Interior - Front Seat Cushion Trim Loose

TSB 05-19-10

LOOSE SEAT CUSHION COVER TRIM ON FRONT OF FRONT SEAT

FORD:
2005 Mustang

Figure 1

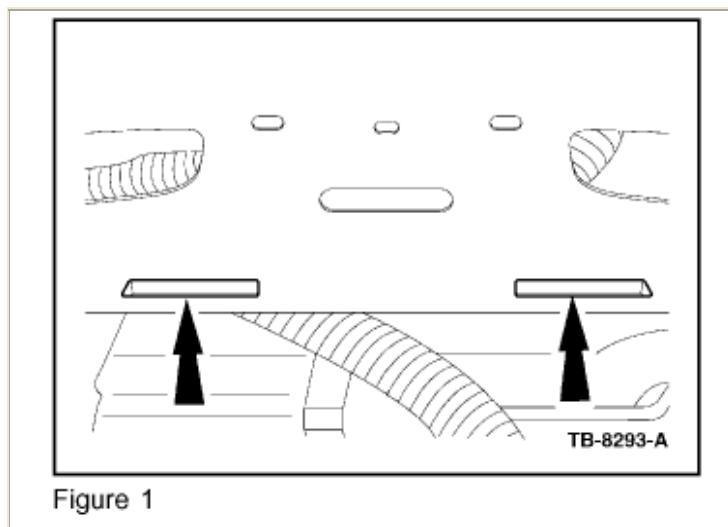
1. Pull back the seat cushion cover trim and foam to access the (4) flanges in the seat pan (Figure 1).

Figure 2

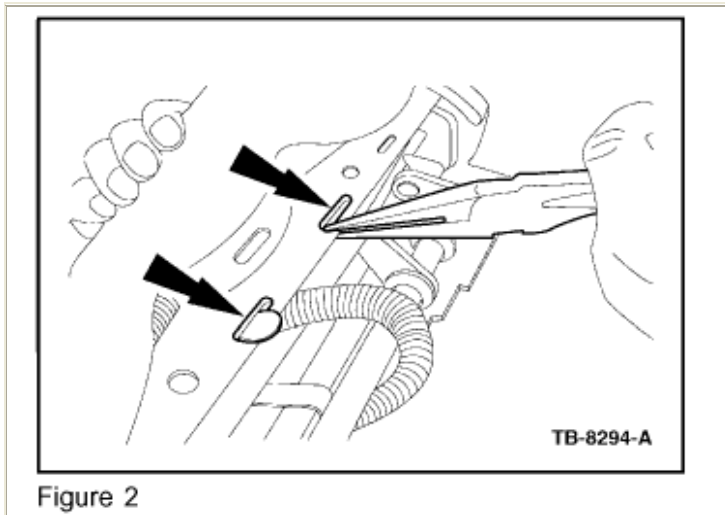
2. Using a needle nose pliers, bend the inside lip of the four (4) flanges toward the rear of the seat, to open the flange slightly. Use a dime to gauge the new opening (Figure 2). The dime should fit tightly when pushed into the adjusted flange opening.
